# REVIEW OF GREERS FERRY DAM DESIGN

MISCELLANEOUS PAPER NO. 3-582

**SUBJECT:** Review of Greers Ferry Dam Design

## REVIEW OF GREERS FERRY DAM DESIGN

FIG. 1 - PLASTICITY CHART

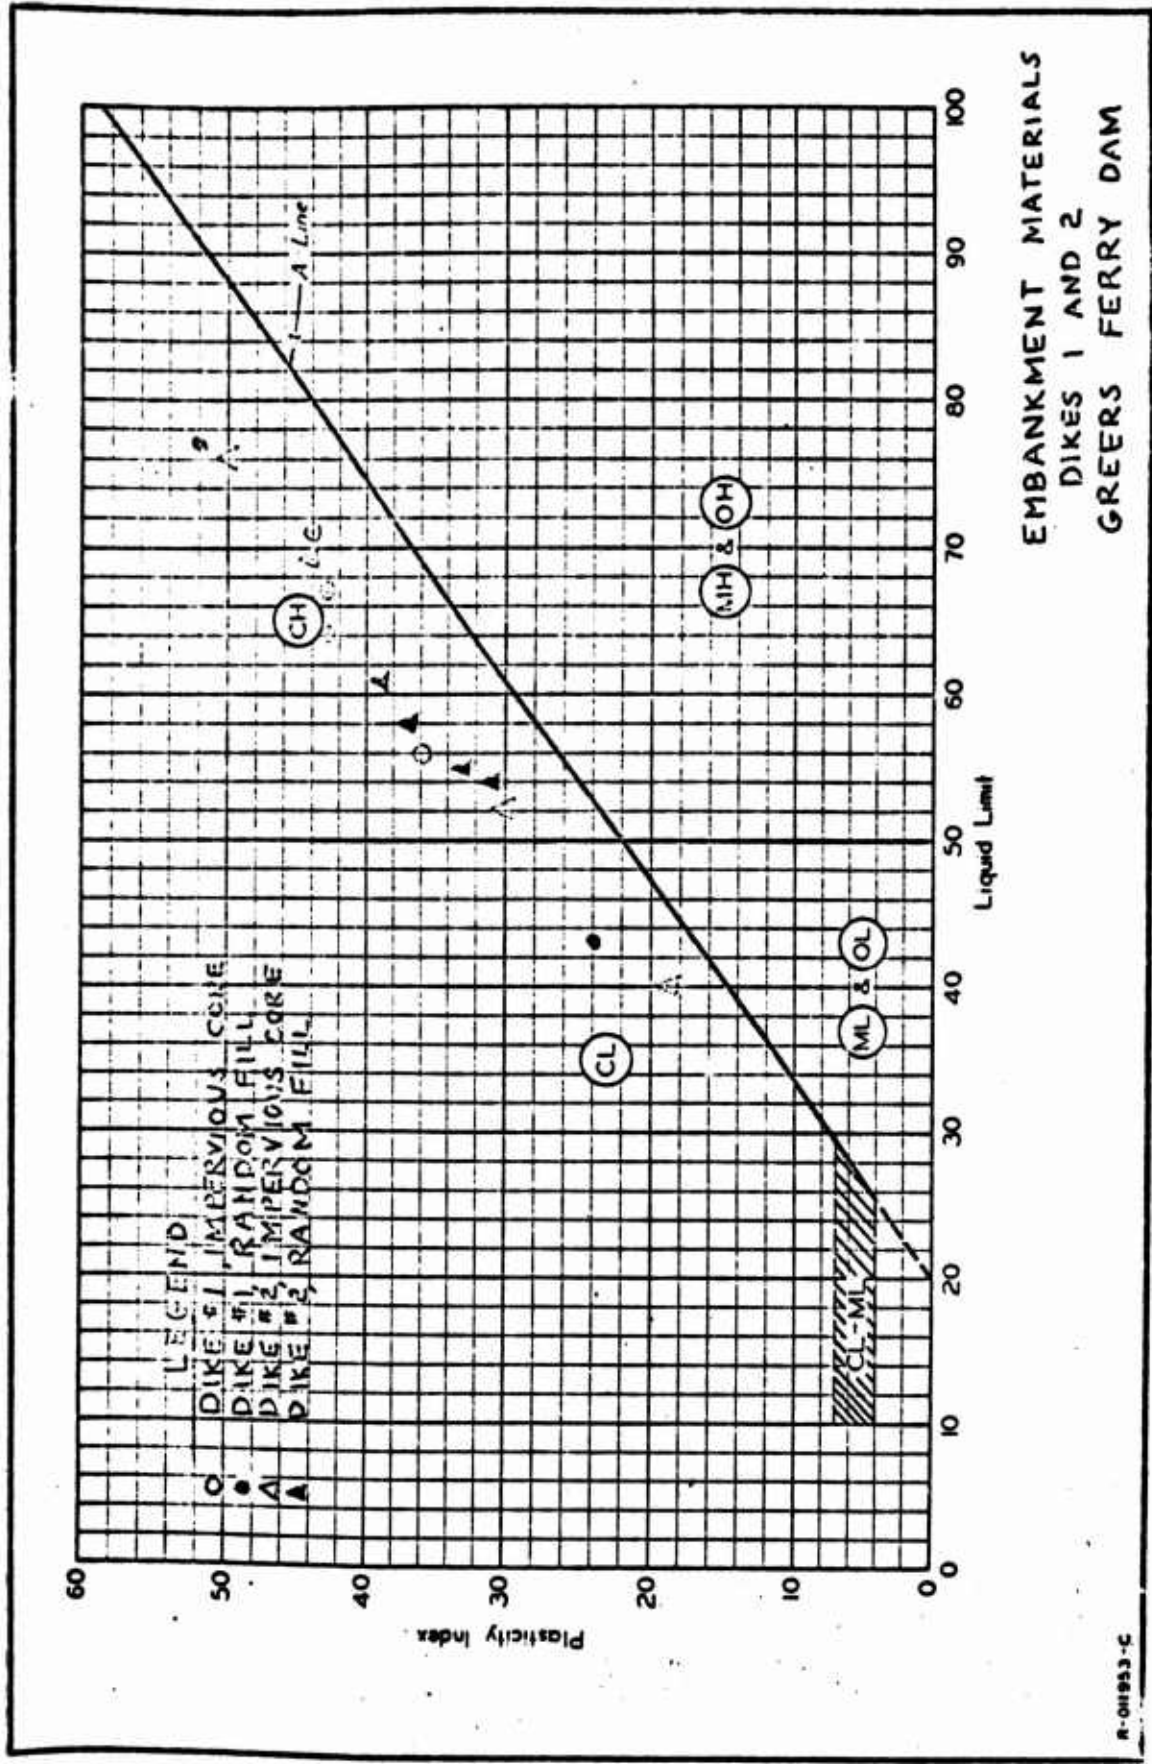
4. Record samples. Record samples taken from the dike embankments indicated a considerable variation in materials in both the impervious core and random fill sections. The materials consisted primarily of lean and fat clays and shale with varying amounts of gravel and sand. Atterberg limits for the embankment materials are shown in the plasticity chart (see fig. 1). Because of the wide variation in material types and the limited number of record samples, a direct comparison of the densities of the record samples with the maximum densities determined in the laboratory could not be made. Results of standard compaction tests listed in table 3 of DM No. 8 indicate optimum water contents ranging from 12.7 to 26.0 percent and maximum dry densities ranging from 95.8 to 123.0 lb/cu ft. These values represent both the core and random fill materials. It was assumed in design that mixing of the borrow soils would occur to such an extent that no one type of material would form an extensive or continuous zone in the embankment and that field densities of 97.5 percent or greater of standard AASHTO density would be obtained during construction. It is understood that zonation was effected during construction by selected routing of hauling equipment so that materials with the greater percentages of rock fragments were placed toward the outer slopes of the dikes. Record samples from the impervious core section indicated placement water contents ranging from 14 to 28 percent and dry densities ranging from 96 to 117 lb/cu ft. The data from the record samples indicate an unusually wide range of placement conditions, reflecting the variability of the materials used.

FIG. 2 - RESULTS OF LABORATORY SHEAR STRENGTH TESTS ON RECORD SAMPLES, DIKE No. 1

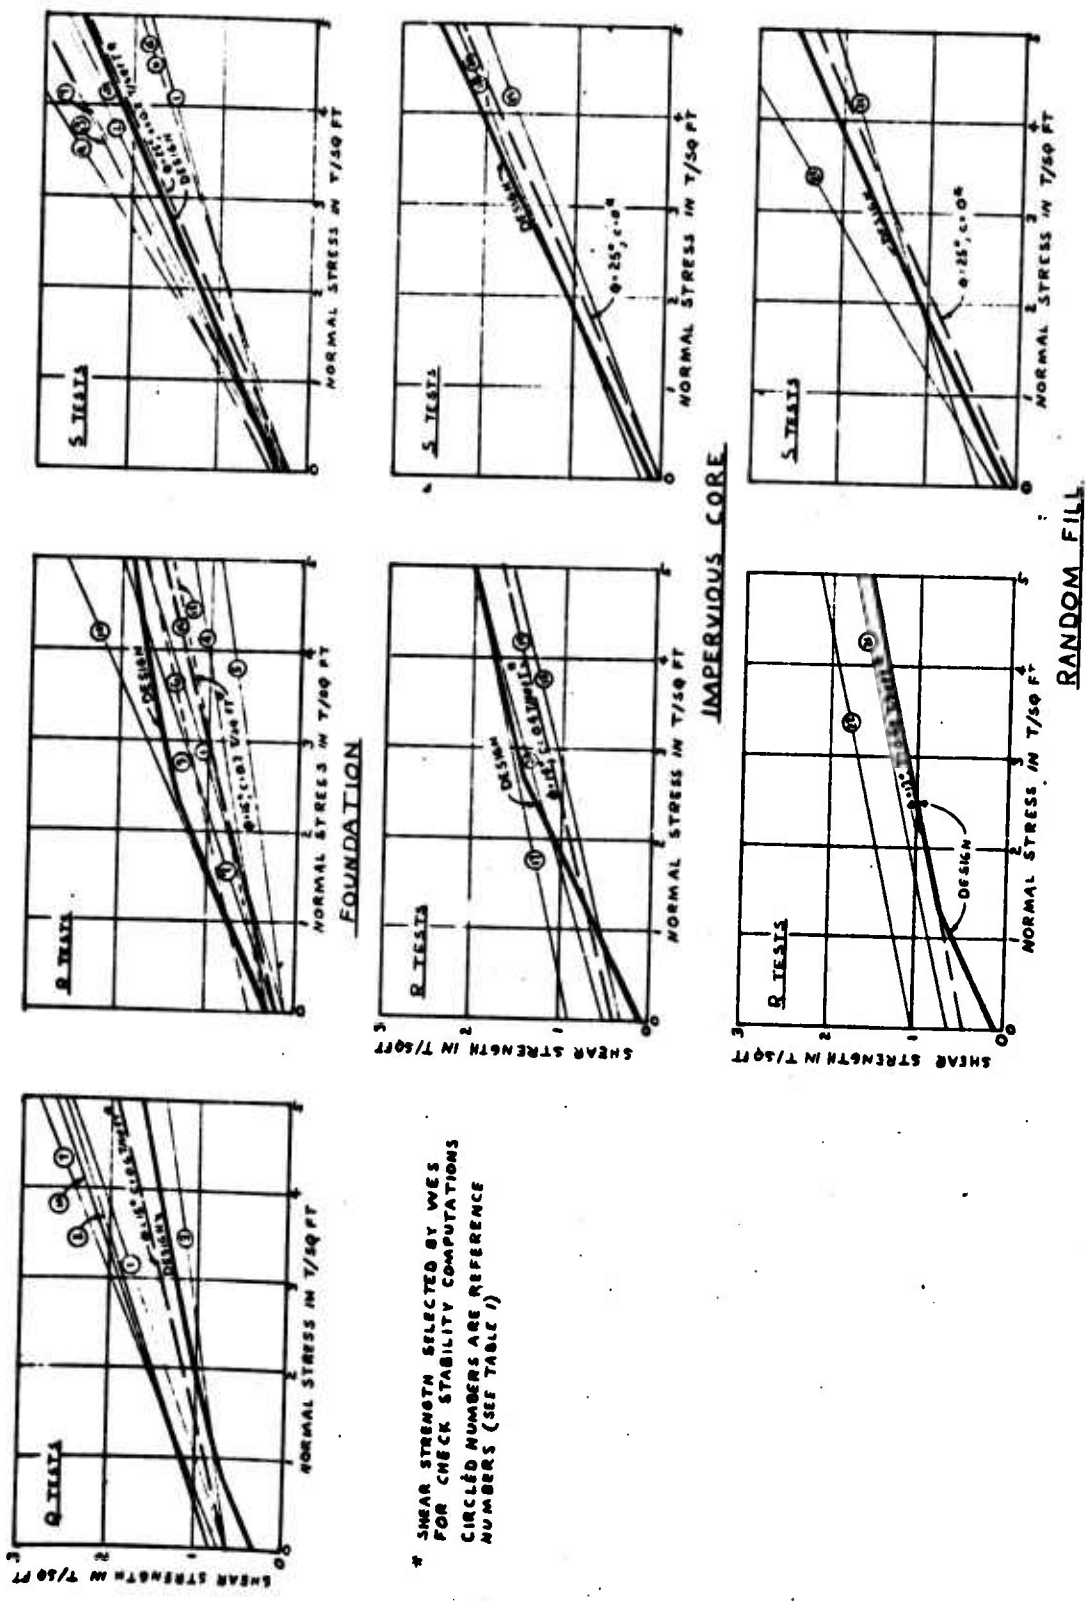
5. Results of laboratory shear strength tests on the record samples are tabulated in tables 1 and 2 and are shown graphically in figs. 2 and 3. The reference numbers shown adjacent to shear envelopes in figs. 2 and 3 correspond to reference numbers shown in tables 1 and 2. Shear strengths were selected for check stability computations utilizing the results of laboratory shear strength tests on record samples from the foundation and from the impervious core and random fill sections of dike 1. Shear strength values selected were as follows:

The above-listed shear strengths are shown graphically in figs. 2 and 3, together with the shear strength envelopes used in design. The design shear strengths consisted generally of combined strength envelopes (see plate 19 of DM 8); consequently, a direct numerical comparison with the shear strengths based on record samples is not possible. In some cases the shear strengths used in design were more conservative than WES selected values, while in other cases the strengths used in design were less than those used in our computations. In general, the shear strengths based on record samples did not differ greatly from the design shear strengths.

FIG. 3 - RESULTS OF LABORATORY SHEAR STRENGTH TESTS ON RECORD SAMPLES, DIKE No 2

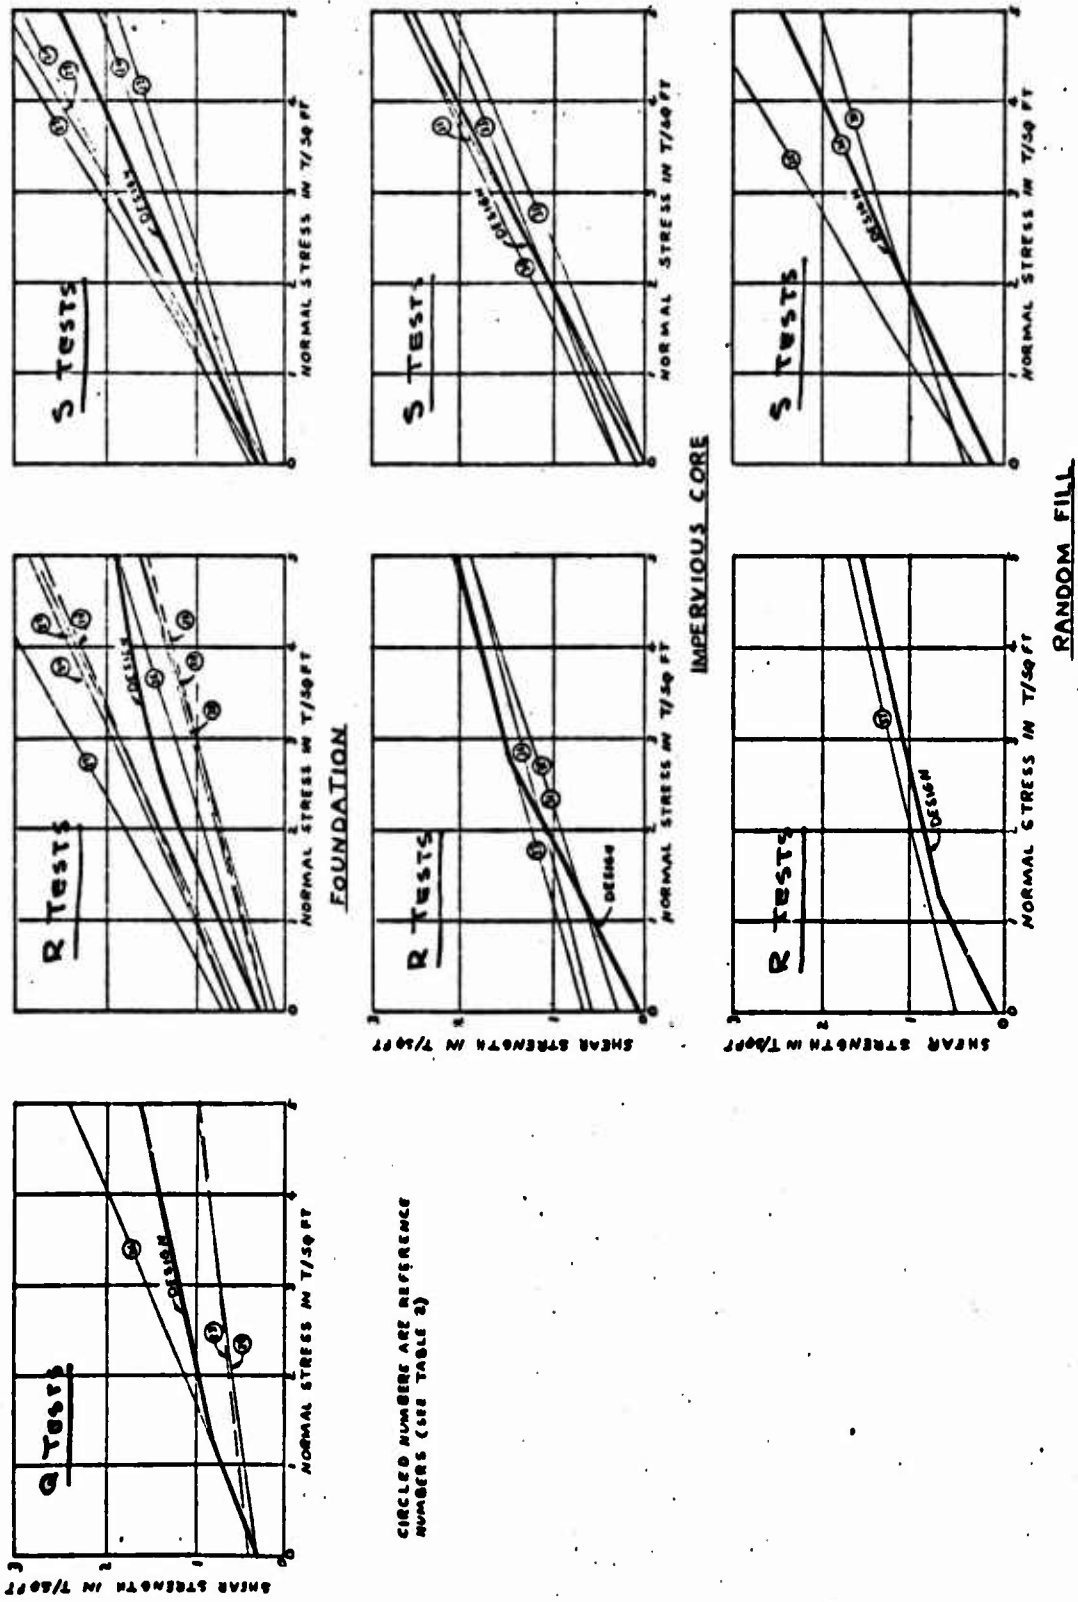
7. Check stability analyses were performed on a typical section of dike 1 (see fig. 4). Dike 1 is about 80 ft high, whereas dike 2 is only about 30 ft high. Strength tests on record samples from dike 2 (see fig. 3) indicate that materials used in dike 2 were similar to those used in dike 1. Although no stability analyses were performed on dike 2, it is considered that this dike is inherently more stable with respect to sliding than dike 1 because of its lesser height.
